DOCUMENT TYPE: POD
DOCUMENT ID #: 21-100793
REVISION: B-000
DOCUMENT TITLE: PACKAGE OUTLINE 25 BUMPS WLP PKG. 0.4 mm
EFFECTIVE DATE: 10/10/2024
EXPIRATION DATE:
CHANGE NUMBER: 1218171
ORIGINATOR: Shaira Isabel Torre

TITLE PACKAGE OUTLINE 25 BUMPS WLP PKG. 0.4 mm PITCH, N252G2Z+1			
APPROVAL	DOCUMENT CONTROL NO.	REV.	1/1
	21-100793	B

BOTTOM VIEW

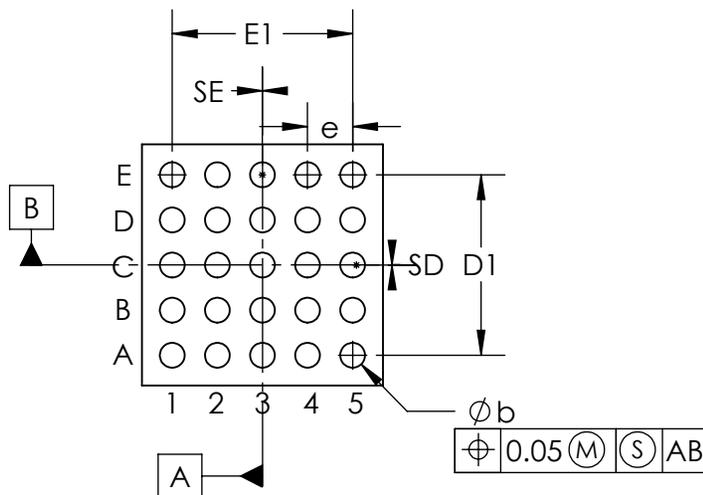
REASON FOR CHANGE:
Change B value from 0.22 TO 0.27

COMMON DIMENSIONS	
A	0.50 MAX
A1	0.22 ±0.03
A2	0.25 REF
A3	0.025 BASIC
b	∅0.27 ±0.03
D	2.138 ±0.025
E	2.138 ±0.025
D1	1.60 BASIC
E1	1.60 BASIC
e	0.40 BASIC
SD	0.00 BASIC
SE	0.00 BASIC
DEPOPULATED BUMPS: NONE
